CAMPUS AREA NEIGHBORHOOD ASSOCIATION

## **Lake Street Garage Steering Committee Report**

November 21st, 2022

**Alternate Layout**

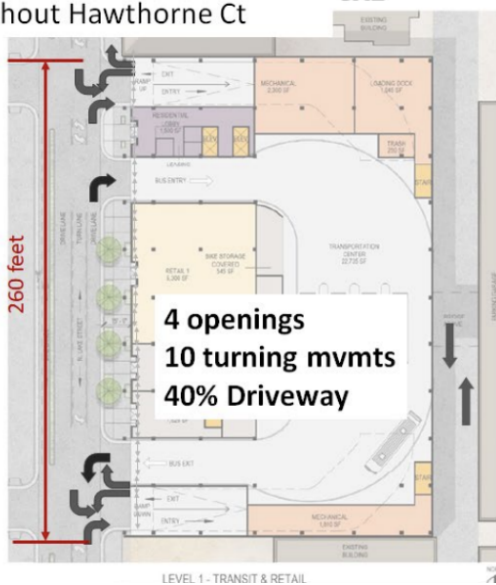
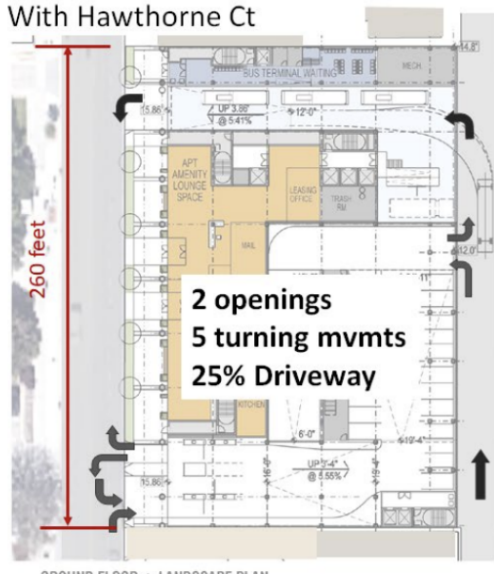
Residents provide feedback on the bus terminal that covered topics of rider amenities and bus parking. People were concerned about the opening to Hawthorne that could be used by people as a cut-through to bars during gamedays and other events. There were no clear amenities described for riders and how the bus terminal would be managed. The development team should anticipate parents and children using the terminal and consider how the project will provide adequate safety measures and security for riders. There are families that use the bus and having kids around so much traffic presents a safety issue. Also, having the bus terminal open on Hawthorne Ct invites drunk people to cross here on their way from bars and does not provide a good experience for people waiting for the bus. This is problematic for pedestrian traffic of riders going to and from the bus terminal. The steering did not enjoy the transparency of understanding why this site was chosen for the bus terminal and what other locations were studied.

The traffic flow of the current proposal requires intercity buses to cross important, busy lanes of traffic that include **the Major BRT (Bus Rapid Transit) Lane, the unprotected Bike Lane, and the Major Sidewalk**. This is a major logistical flaw as this presents lots of opportunities for major backups on University Ave due to buses not being able to cross the lanes of traffic and a higher risk of accidents due to the Hawthorne Ct functioning as an alleyway and not being a controlled intersection. Not to mention University Ave is a much faster street than Lake Street and increases the risk of accidents like fender benders and bikers being hit during rush hour traffic. The development needs to use Lake Street for buses because it is a controlled intersection with a stoplight as compared to the Hawthorne Ct entrance which has no traffic signals. Additionally, the East Campus Mall BRT Spot can be inferred as a major bus stop for students commuting across campus. The three major residence halls are within a couple of blocks of this spot. Blockages at the Hawthorne Ct entrance will disrupt this major BRT system hub.

The three spots for buses seem inadequate and are shortchanging the intercity bus station potential. The bus terminal ought to have five bays like the old bus terminal and there needs to be a better plan for staging. They are trying to do too much at once and seem to be modeled after La Crosse without consideration of the unique challenges of this area. The Bus terminal is different and you can drive straight through it. This design

seems too complex at the moment. The proposal does not seem to completely address everything. The entrances for residential parking are on the same side as the Van Galder Bus entrance. This mix of traffic seems problematic with bus schedules and the residential experience. If there is a queue that wraps around the corner, this will affect the BRT lane and Metro Bus lane. There is also a need for more entrances and exits to accommodate queues during special events.

Without Hawthorne Ct

*The alternative layout provided by the City of Madison Transportation Department*
